**TOWN OF BROOKLYN
Inland Wetlands and Watercourses Commission
Special Meeting Minutes
Virtual Webex Meeting
July 28, 2020**

VERSION 3 ENGINEERING PLAN REVIEW

The comments contained herein pertain to my review of the third version of plans, consisting of eight (8) sheets, entitled "Subdivision Application, 5 Lot Subdivision, Prepared for VBL Properties, LLC, Beecher Road, Brooklyn, Connecticut," prepared by Archer Surveying, LLC and CLA Engineers, Inc., dated June 4, 2020 with revisions as recent as July 8, 2020. Most recent Town of Brooklyn Zoning, Subdivision and Wetlands Regulations and Public Improvement Specifications were researched for this review.

Existing Condition Plan

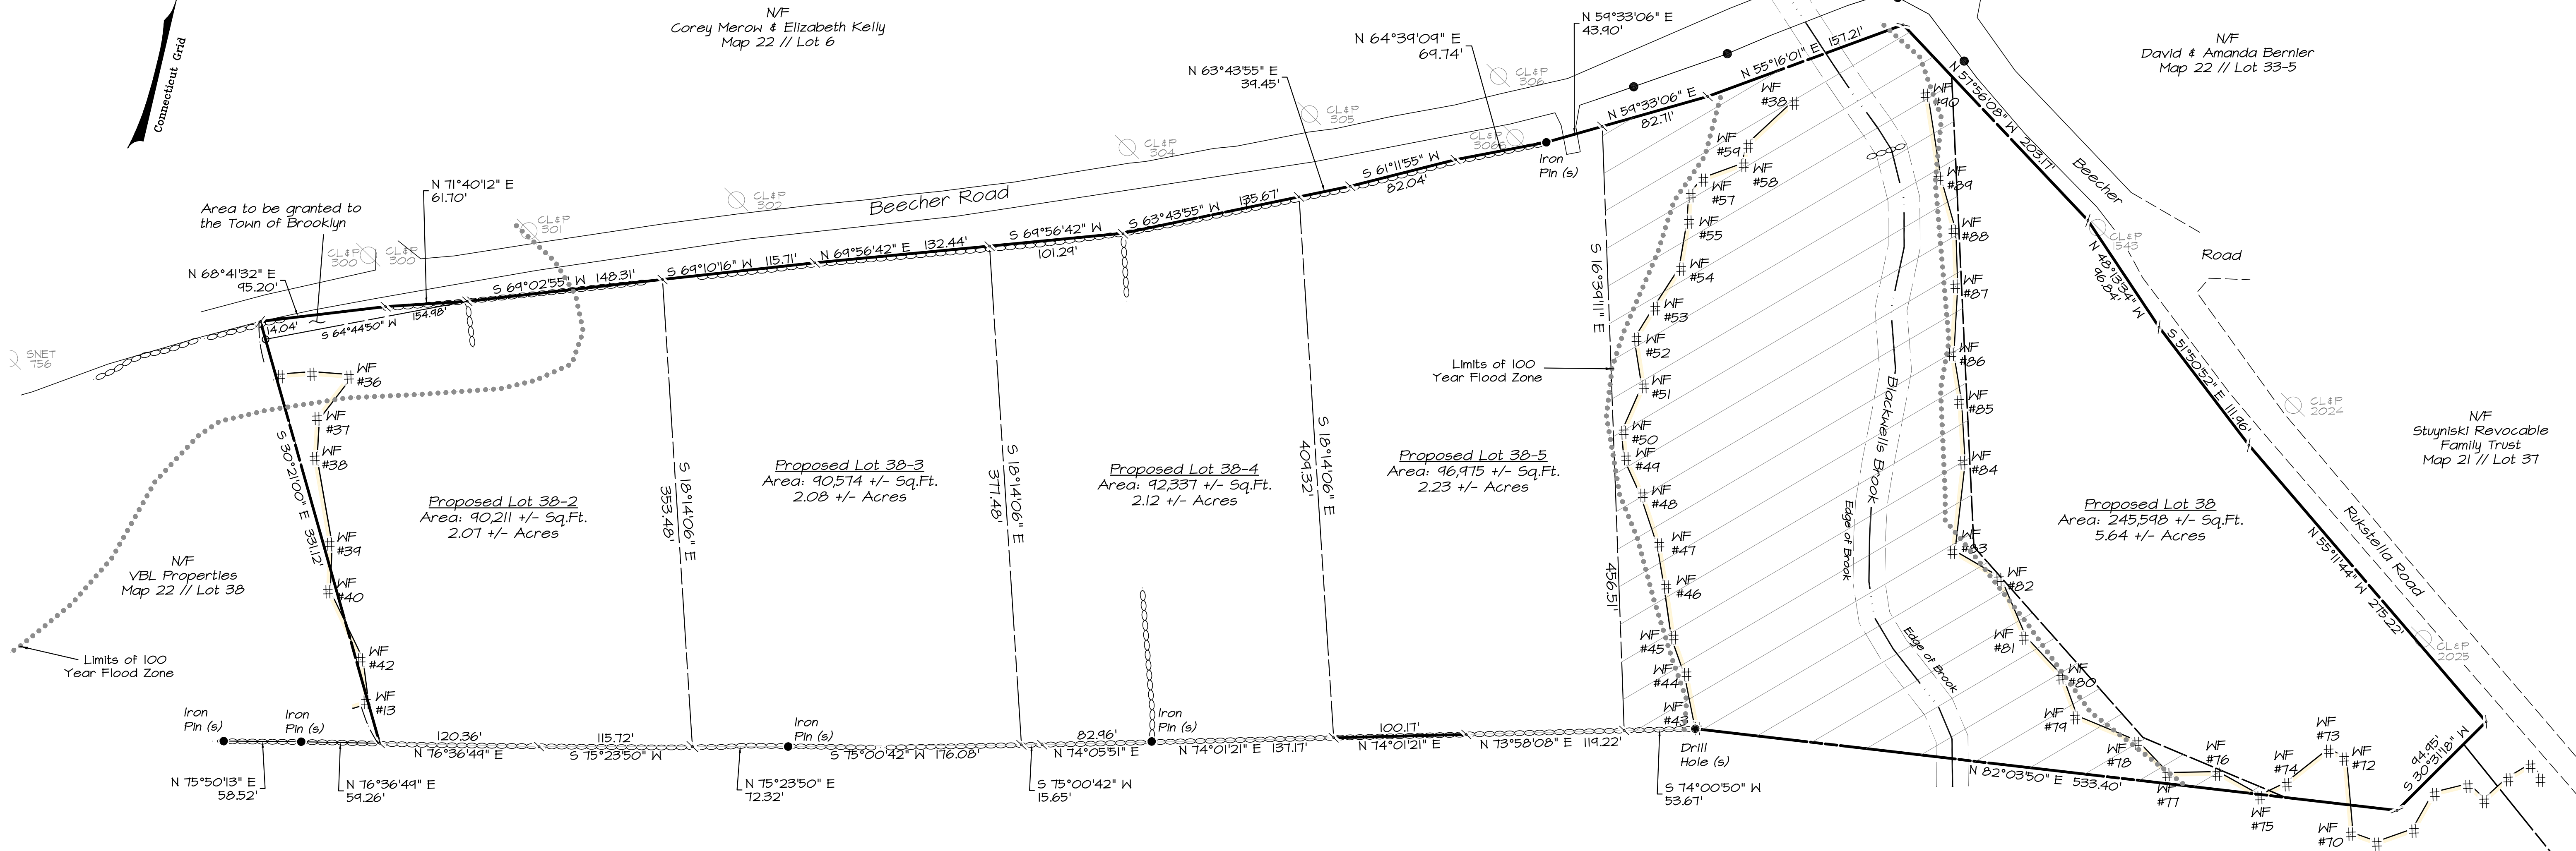
Sheet 2 of 8 – Existing Condition Plan

1. The plan's title block designates this plan as Sheet 2 of 9. This should be changed to Sheet 2 of 8.
2. Previous versions of this plan did not include contour lines, wetlands flagging, 100-year flood hazard boundaries, and expanded map references. Also, "Notes" was expanded from 3 to 12 notes, which are repetitious of those found on Sheet 3 of 8, "Subdivision Plan."
3. A 100-year flood hazard boundary is located at the northwest corner of the property opposite CL&P Utility Poles #300 & #301, however, the flood hazard zone is not shown on Sheet 4 of 8, "Grading & Septic Design Plan 1 of 1."

4. The 100-year flood hazard boundary symbol needs to be included in the plan "Legend."
5. The professional land surveyor's seal and signature is missing on this plan.
6. The soil scientists name and signature is missing on this plan.

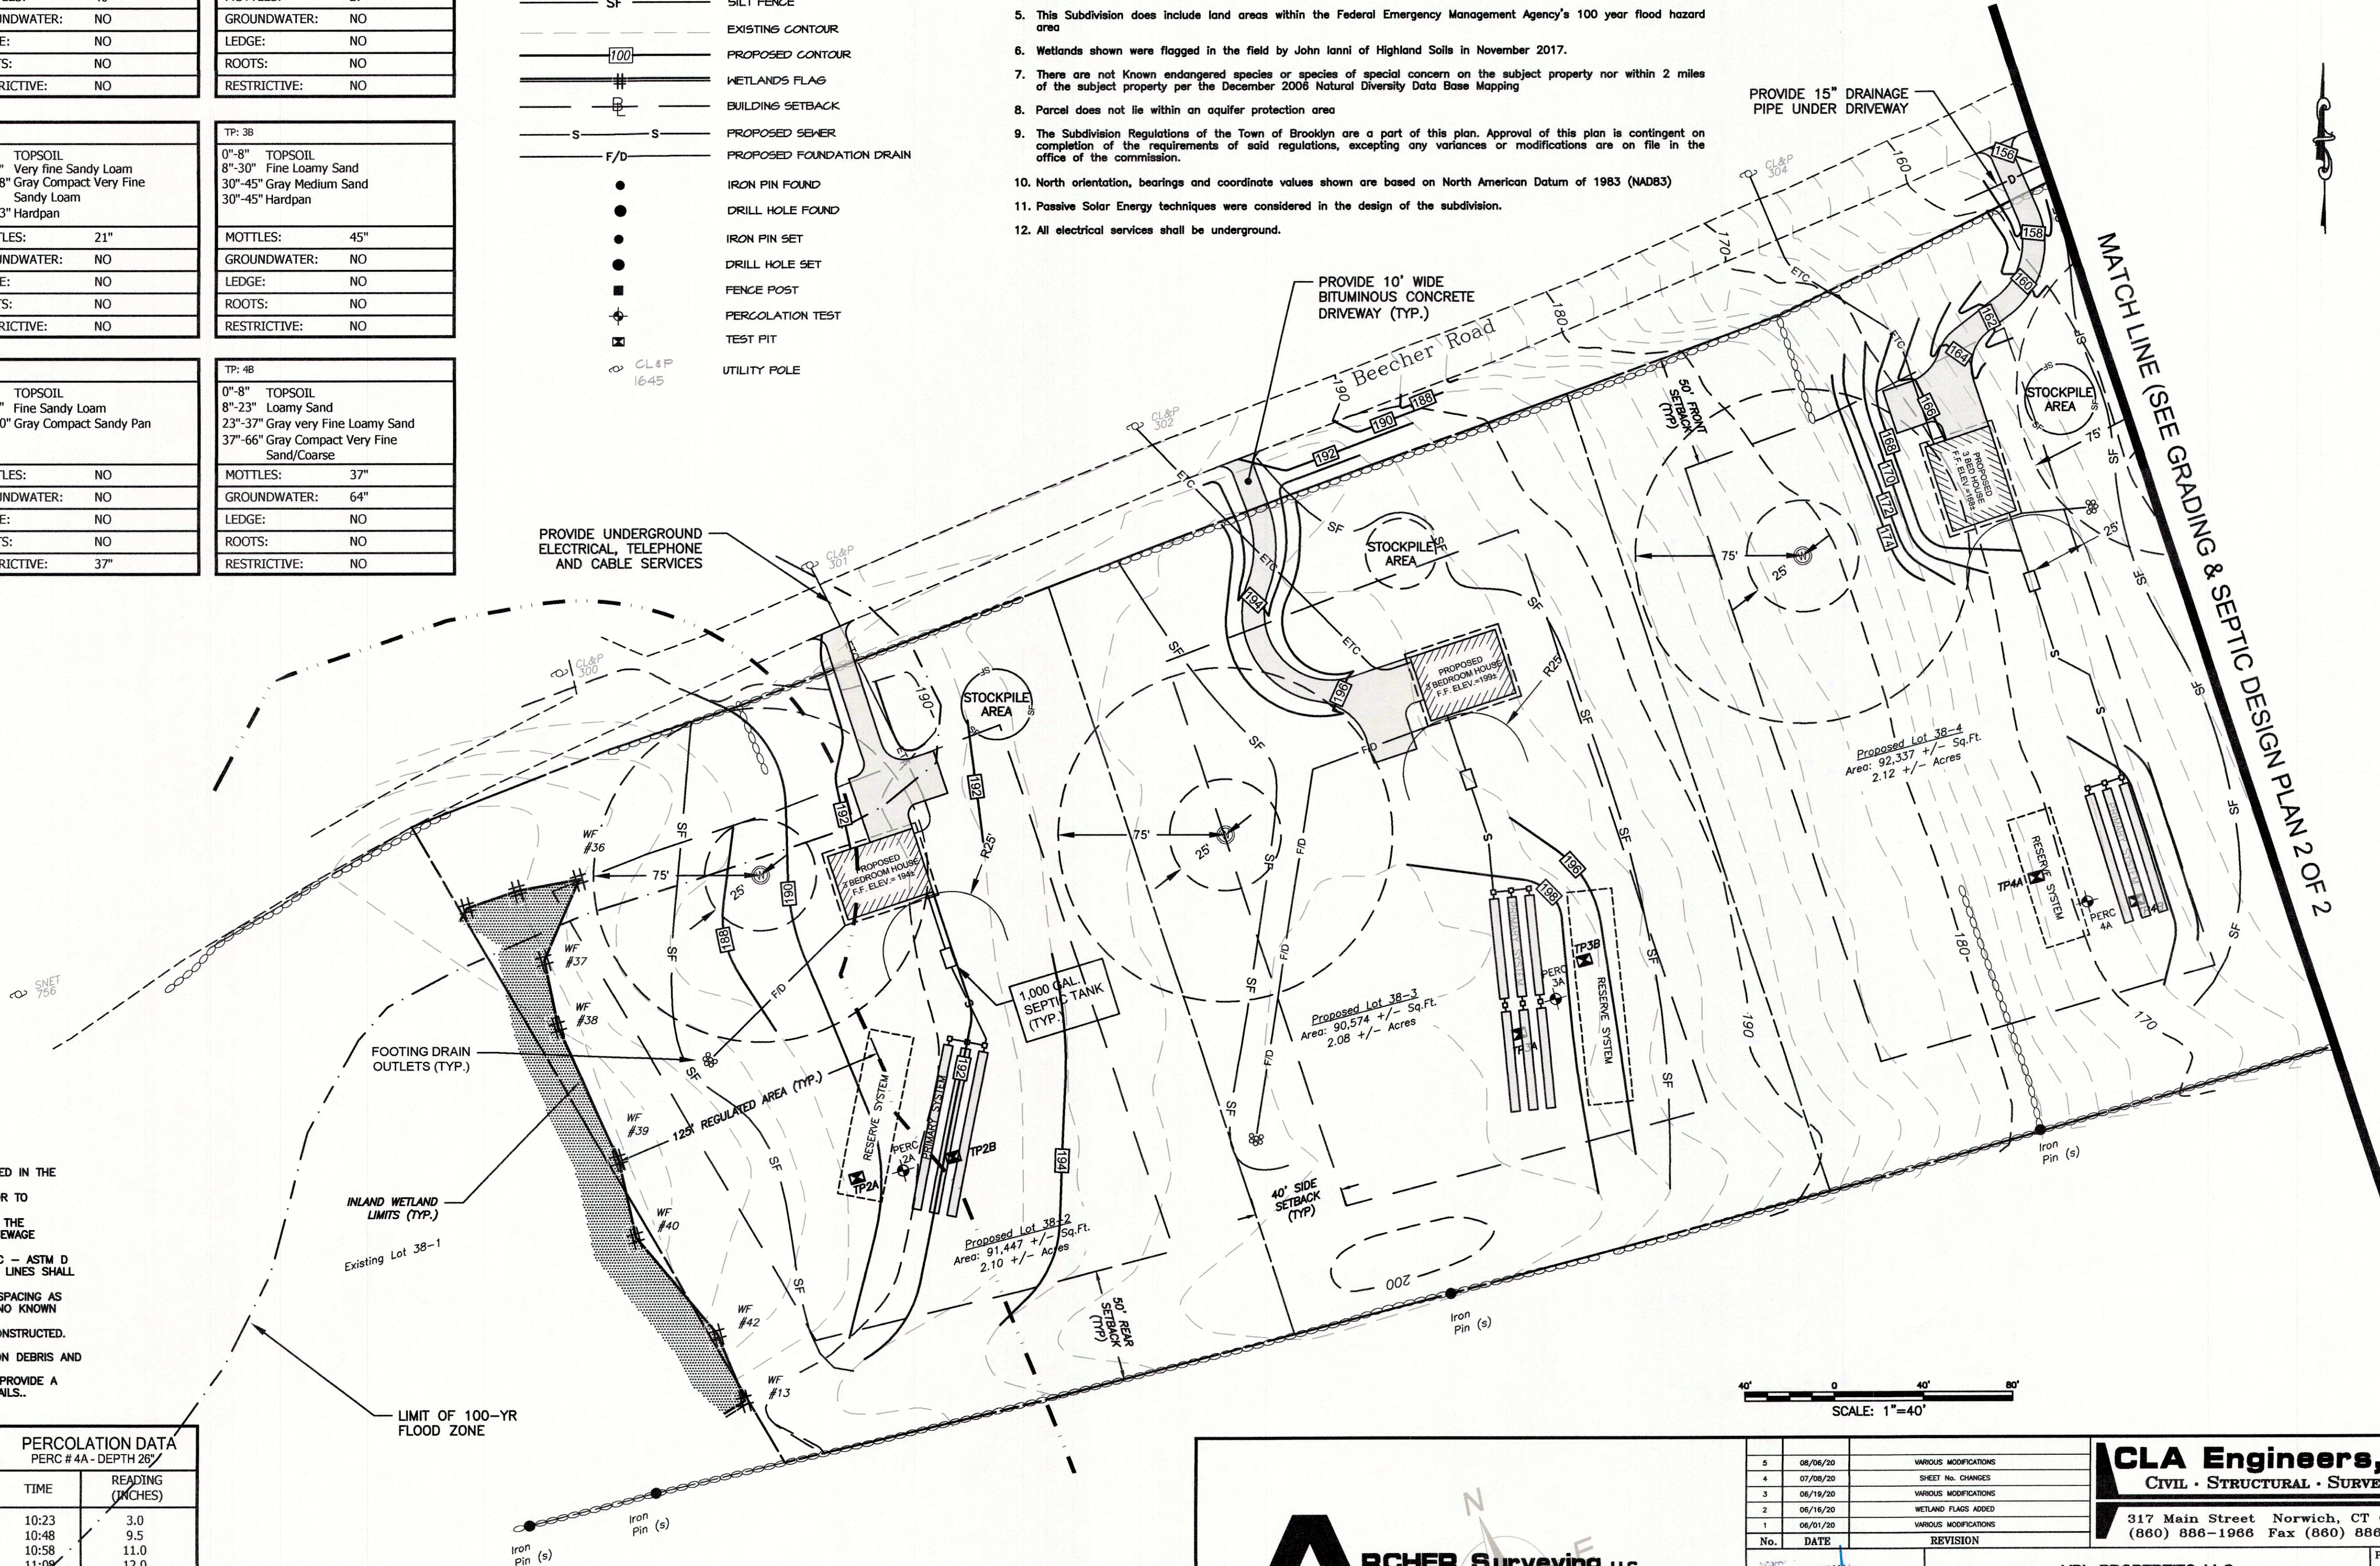
Sheet 4 of 8 – Grading & Septic Design Plan 1 of 2

1. The 100-year flood hazard boundary is not shown along the frontage of Lot #38-2. Based upon the location of the boundary shown on Sheet 2 of 8, the depicted location of the well for this lot may be in or on the edge of the flood hazard zone. It is recommended that another location be considered for the well if the designer feels this has the potential for well contamination with an opinion stated in writing to the Commission.
2. The 100-year flood hazard boundary symbol is not included in the "Legend."

GRADING & SEPTIC DESIGN PLAN 2 OF 2

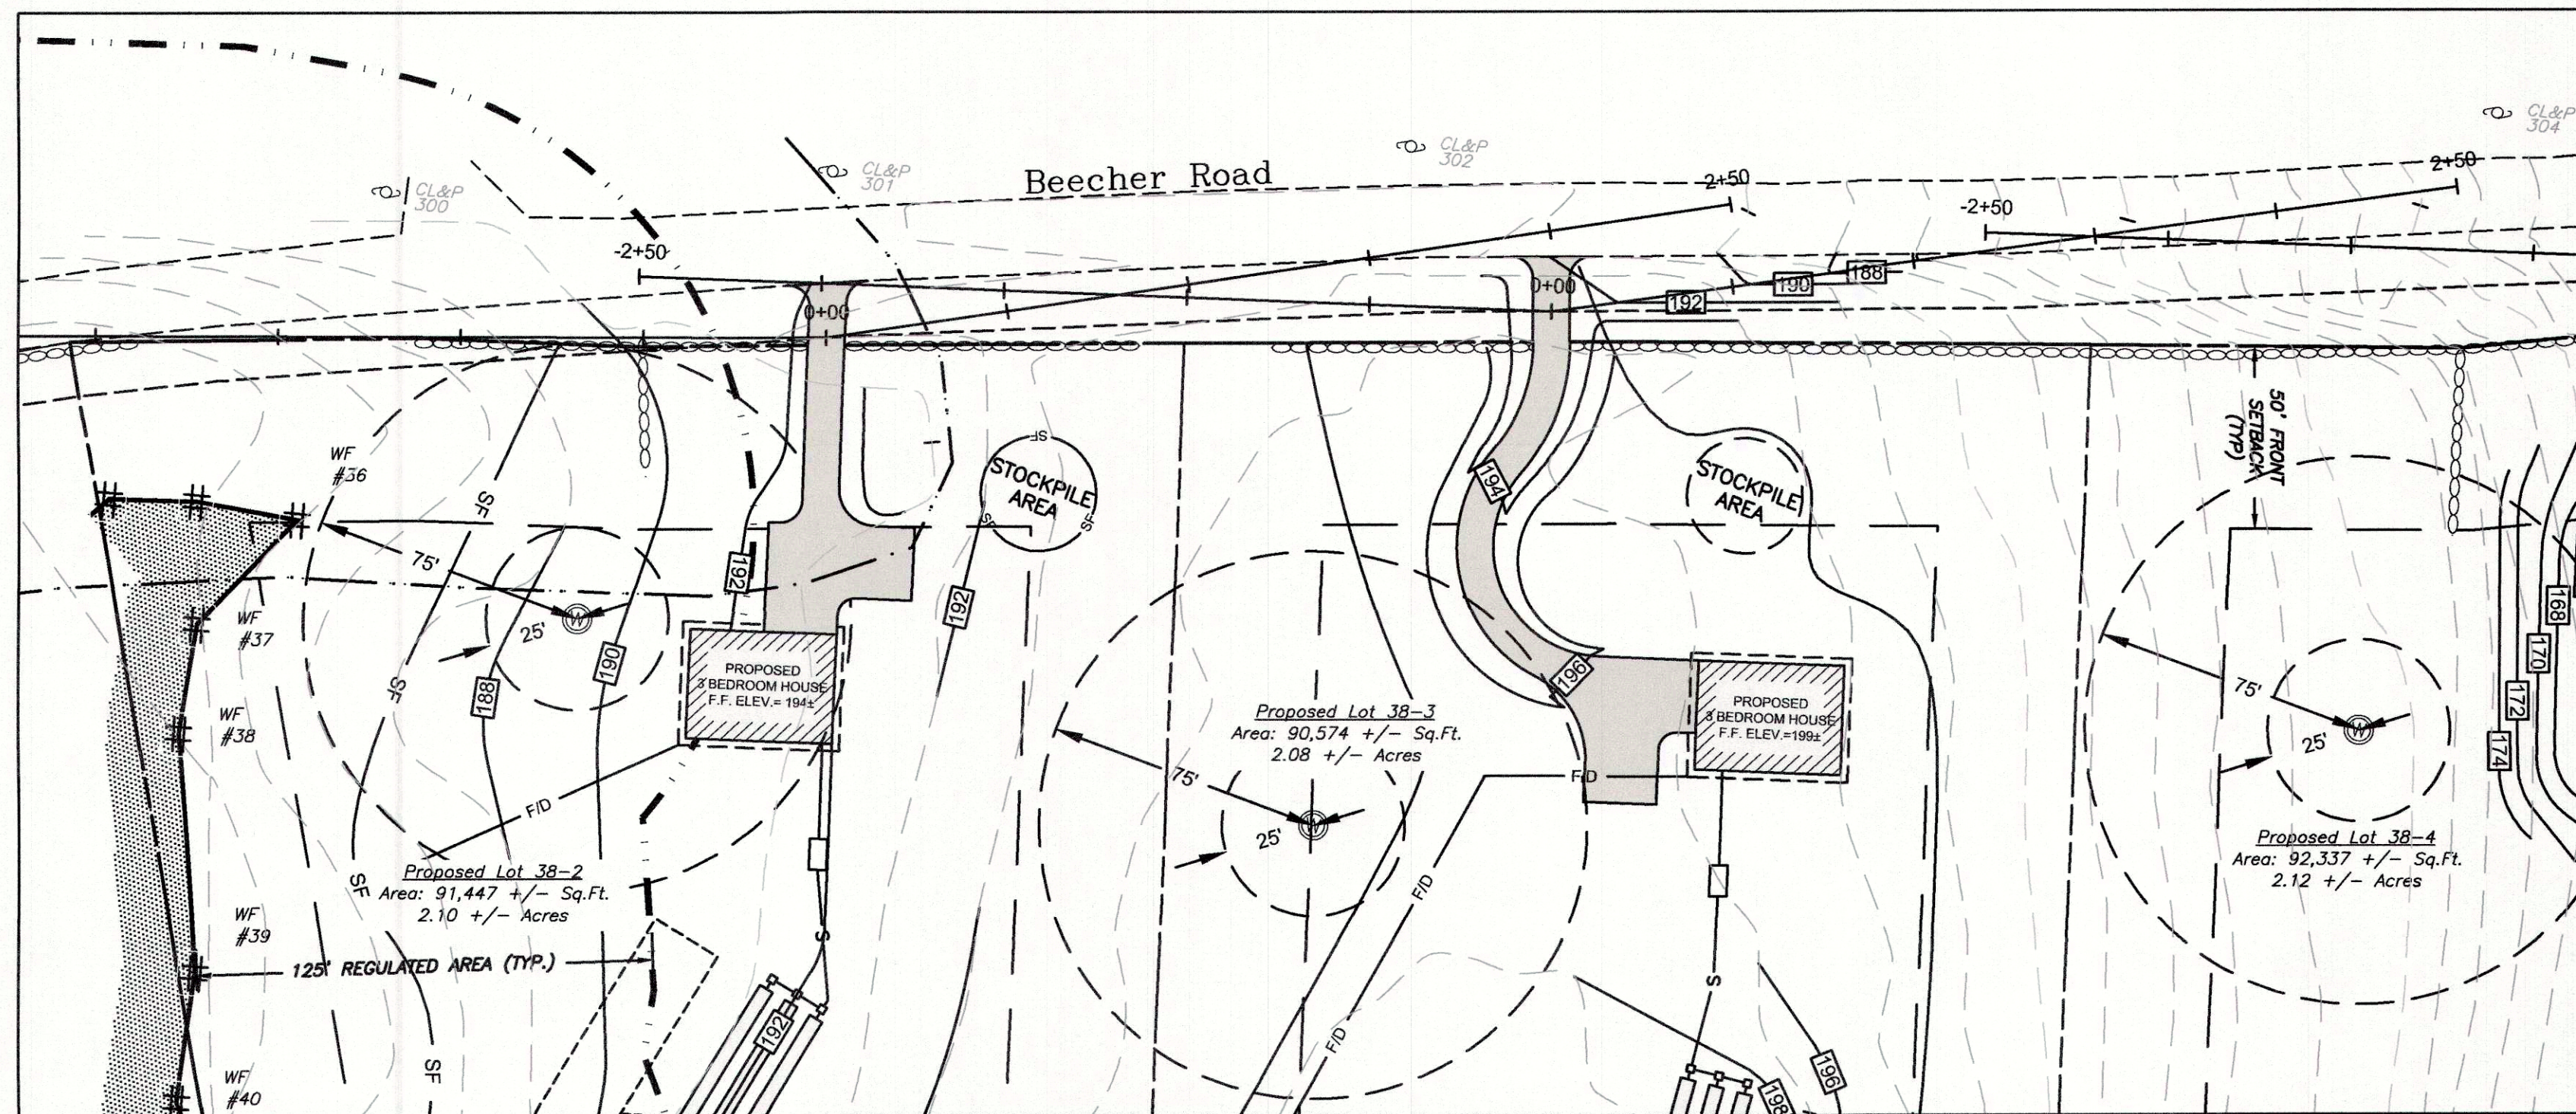
Sheet 5 of 8 – Grading & Septic Design Plan 2 of 2

1. Lot No. 38 on Sheet 5 of 8 is almost entirely contained within a regulated wetland upland area. No one can argue that Blackwells Brook is an important watercourse in the town of Brooklyn and as such any development or land disturbance close to it, especially within the wetland upland review area as shown, should be done with extreme care, if at all. The proposed lot, if approved as shown, is to be developed with a two-family house, paved driveway and significant clearing/regrading of the lot as close as 100' from the stream. Introducing habitation in this area provides no guarantees that the future residents will recognize the importance of protecting the water quality of this stream and not create further modification (e.g. cutting trees) of the upland area to, for example, increase more usable yard space,

provide more natural light in the yard or install a swimming pool, all of which can be detrimental to the wetland. Considering this, I believe very careful thought must be given as to whether or not this lot should be created at all—especially with a duplex dwelling—due to the potential negative impact to the Blackwells Brook wetland system.
